Docket Number:	16-BSTD-03
Project Title:	Updates to the 2016 Residential Alternative Calculation Method Reference Manual and Software
TN #:	211201
Document Title:	NegaWatt Consulting on behalf of SoCalGas Comments: SoCalGas Reponse to 2016 Residential ACM Reference Manual and Software
Description:	Updates to 2016 Residential Alternative Calculation Manual Reference Manual and Software
Filer:	System
Organization:	NegaWatt Consulting on behalf of SoCalGas
Submitter Role:	Public
Submission Date:	4/22/2016 3:25:54 PM
Docketed Date:	4/22/2016

SoCalGas Reponse to 2016 Residential ACM Reference Manual and Software

Updates to 2016 Residential Alternative Calculation Manual Reference Manual and Software

Comments Regarding CEC Docket #16-BSTD-03

Figure 1: Comparison of HPWH TDV Energy Budget for CBECC-Res 2016 v1.0 and v2.0, 2,100sqft standard home

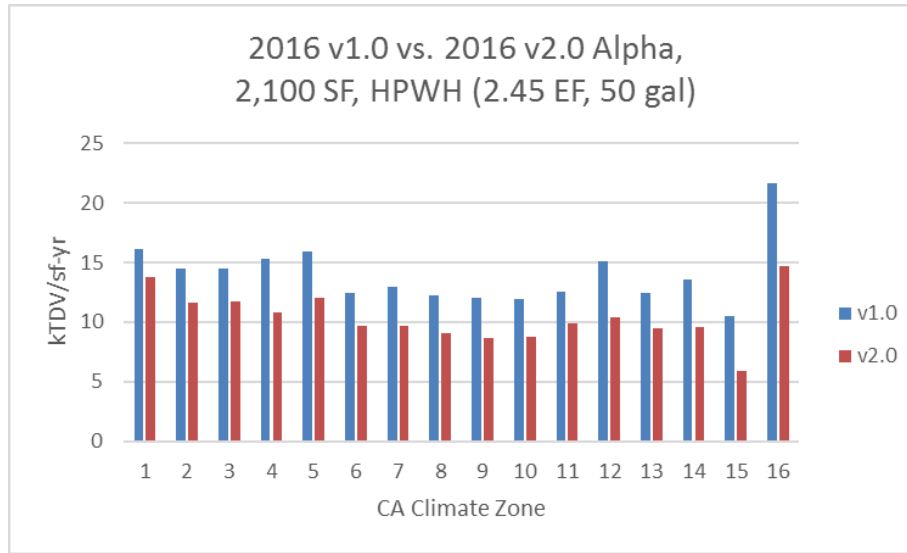
The annual energy budget for heat pump water heaters (HPWH) changed dramatically from version 1.0 to version 2.0 of CBECC-Res 2016 as can be seen in Figure 2 for the 2,100 square foot model home and Figure 2 for the 2,700 square foot home (albeit both with HPWH instead of instantaneous gas) for all climate zones. The average reduction is 26% for the smaller home and 25% for the larger home. In the version 2.0 model, chosen "Heater Type" is "Heat Pump 2016", "HPWH Type" is "Rheem HB 50", and "Location" is "Garage". The AHRI Directory lists this model with an Energy Factor of 2.45 and storage volume of 50 gallons. Those values were used in the v1.0 software to match. We recognize that the v1 HPWH model is a legacy model developed in 1990 when the HPWH and modeling technology was less mature. Regardless, the magnitude of the change is significant and unexpected at first sight, since a spikier draw schedule ought to result in more resistance heating for the load to be met. We recognize that there are plausible explanations for the drop. However, it remains important that stakeholders clearly understand the basis for the change and that its validity is confirmed.

Similar calculations were performed for the completely standard models of instantaneous gas water heaters and for small gas storage water heaters, but only for the 2,100 square foot home for brevity's sake. The percent reduction in energy budget for those from version 1.0 to 2.0 was much smaller at 4 to 5%.

Figure 3: Water heater energy use comparison of different software versions for Climate Zone 7 (San Diego coastal) in kTDV/sqft-yr, for standard homes⁶.

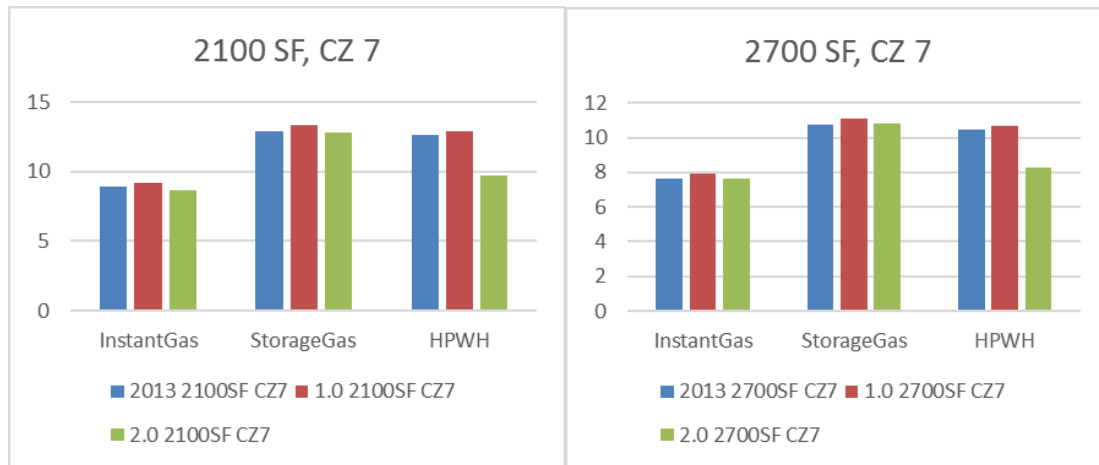
Slide 38 states that HPWHs are valuable for ZNE. However, instantaneous gas water heaters (IWH) in the base case 2,100sf and 2,700sf model buildings still have a lower annual TDV than HPWHs, even by the calculations of the new model and using the new draw schedule (i.e. 2016 v2.0). Figure 3 below illustrates this fact for climate zone 7 by example; other climate zones have comparable results and have only been omitted for brevity.
